April 22, 2022

NOTICE OF CHANGES

Table 2. New Power Cord Assemblies with shorter wires.

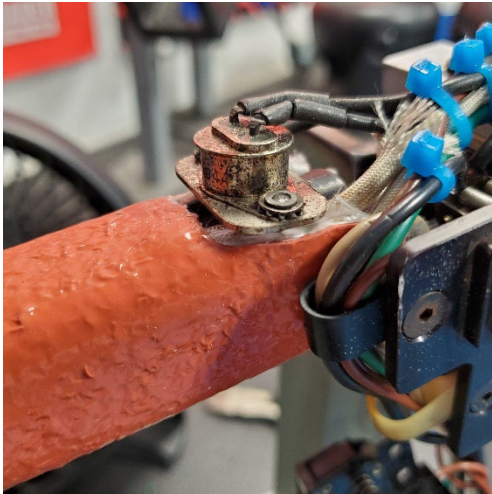
- 1) Drader has updated the Power Cord assemblies by modifying the wire lengths. Please see the tables below to determine which Power Cord assembly to use in a welder repair.

Note: Routing of the wires for these power cords has changed.

Description	New Item ID for modified power cords
120V North America Power Cord Assembly	IASS-A-R14CRDNAM
240V Europe Power Cord Assembly	IASS-A-R14CRDEURO
240V UK Power Cord Assembly	IASS-A-R14CRDUKM
240V Australia Power Cord Assembly	IASS-A-R14CRDAUS
